RE: Radiography License Renewal  
Vollrath Company  
Control #76668

As requested, you will find the following gamma room radiation survey information:

# Exhibit - 2

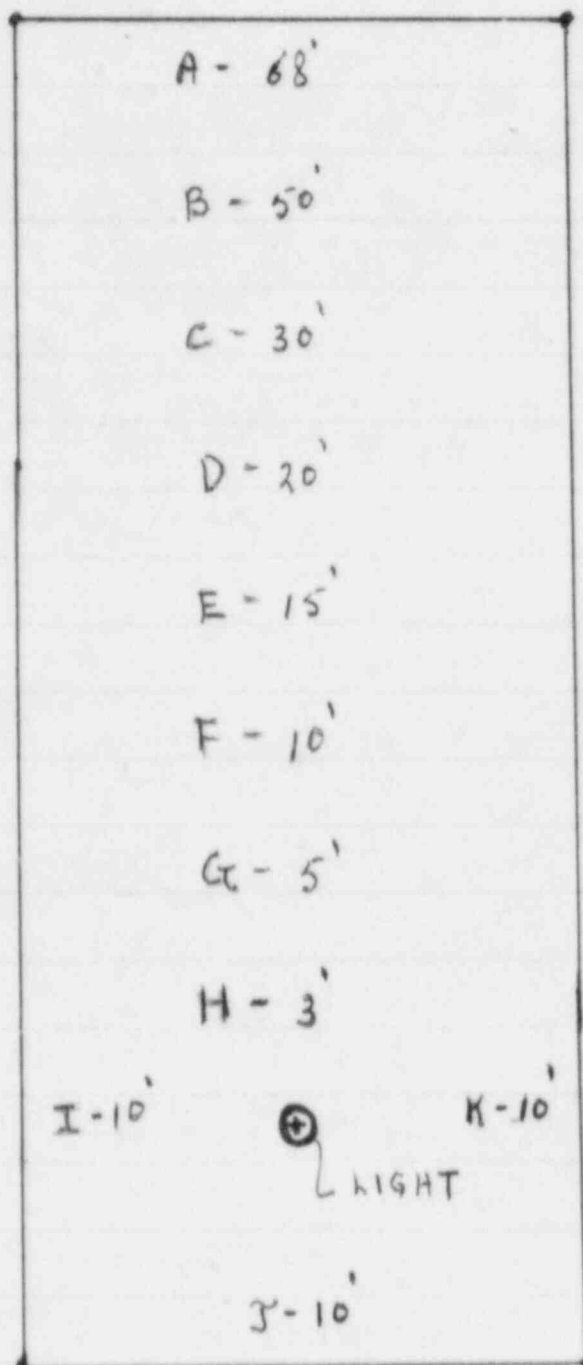
Exhibit 2 - Roof survey. Roof has no access doors and has cable around upper perimeter with signs reading "Caution - High Radiation Area" and "Danger - Keep Off". The roof also has the rotating red flashing light.
